ENGINE - LP COMPRESSOR - FAN EXIT GUIDE VANE A/O - INCORPORATION OF A REVISED BONDING
PROCESS - CATEGORY CODE 6 - MOD.ENG-72-0020

V2500-ENG-72-0020

SERVICE BULLETIN

Reidentification of the Fan Exit Guide Vane A/O (FEGV) - Part 1 of SB
Fig.1

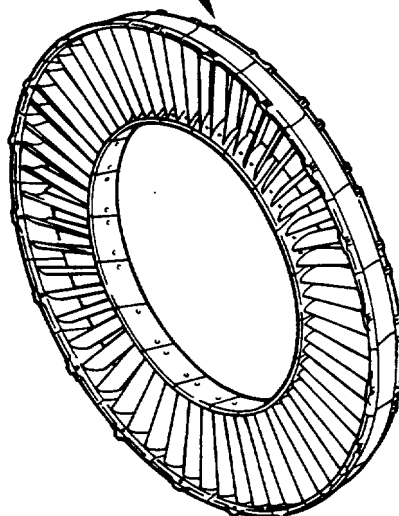
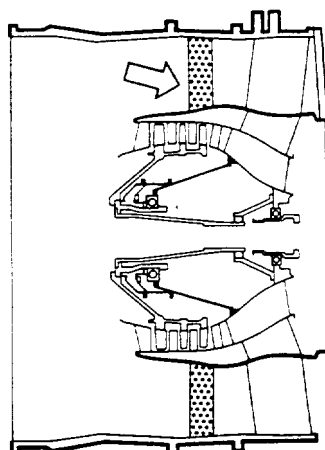
(2) The existing 5A0037, FEGV's which are used the Type II bonding process must be reidentified to the new 5A0283, FEGV's which are the equal part number to that of used the Type III bonding process, to discriminate them from the FEGV's used the Type I bonding process (See Figure 1).

- (a) Reidentify the existing part number of FEGV's which is made a mark on each segment with the Vibro-peen (Refer to Figure 1 and 1.K.(1)(c)).

MARK NEW PN 5A0283 BY VIBRO-PEEN ADJACENT TO OLD PN 5A0037 IDENTIFIED HERE. MARK TWO LINES (==) ON OLD PN BY VIBRO-PEEN TO ERASE IT.

5A0037 FEGV A/O
RENUMBER TO PN 5A0283
FEGV A/O (20 Segments)

Location of the Fan Exit Guide Vane A/O (FEGV) - Part 2 of SB Fig.2

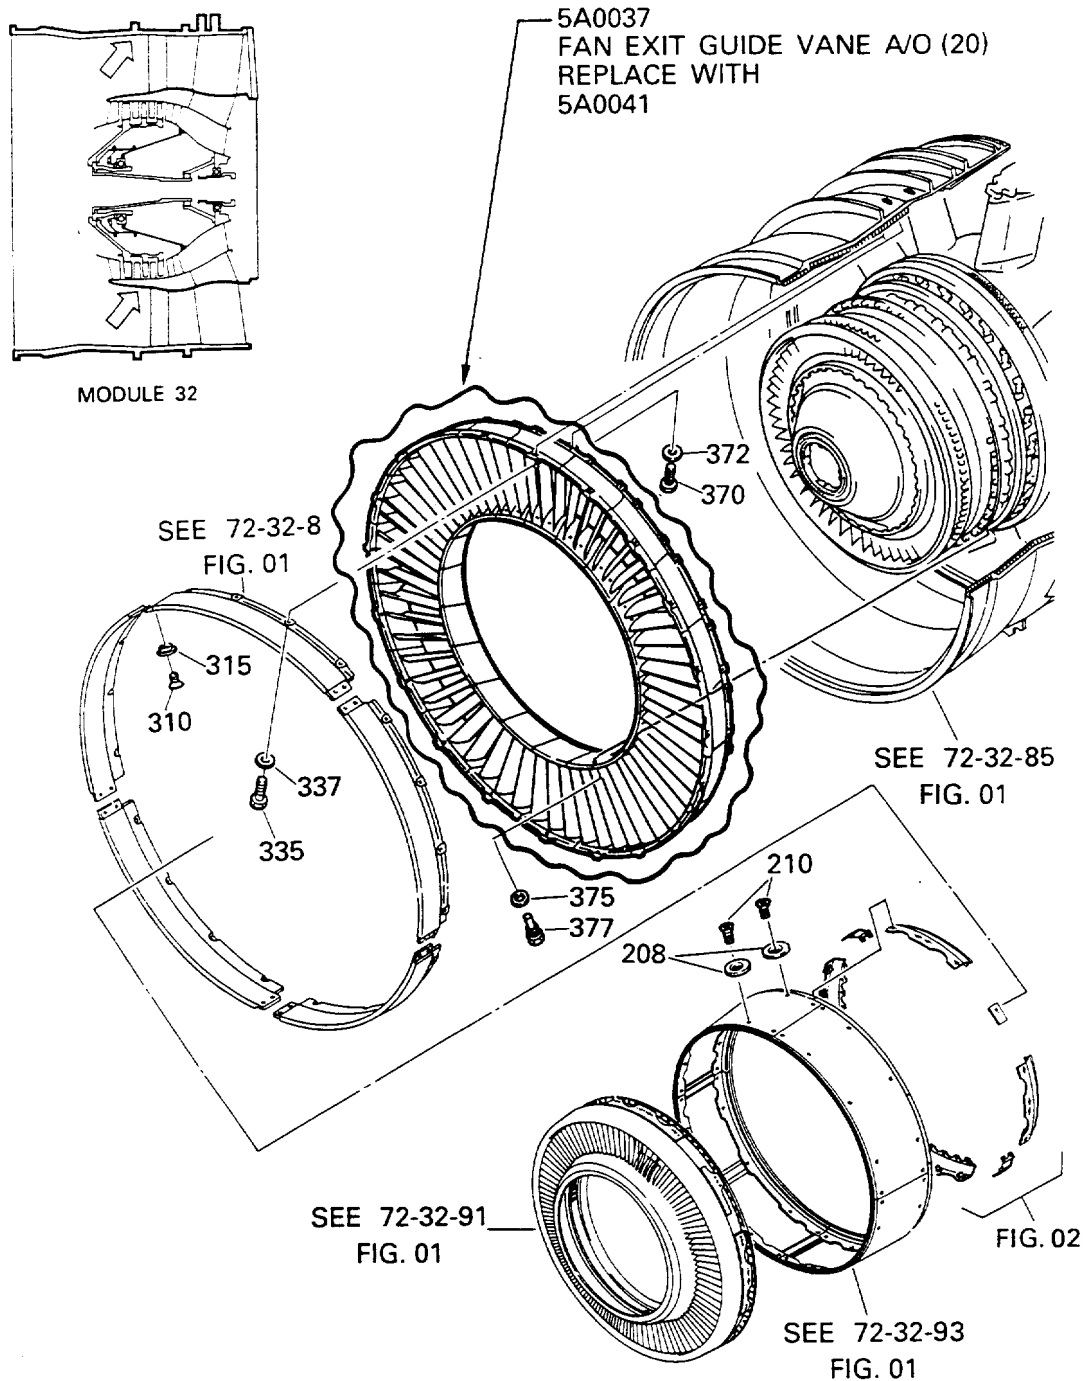
(3) The existing 5A0037, FEGV's which are used the Type I bonding process must be replaced with the improved FEGV's which use Type III bonding process (See Figure 2). The existing FEGV's removed from service can be reworked by engine manufacturer.

- (a) Remove the 20 segments of 5A0037, FEGV's by the approved procedures in the Aircraft Maintenance Manual 72-32-88, TASK 72-32-88-000-010. (Refer to 1.K.(2)(a)).
- (b) Install the 20 segments of 5A0041, FEGV's by the approved procedures in the Aircraft Maintenance Manual, 72-32-88, TASK 72-32-88-400-010. (Refer to 1.K.(2)(a)).
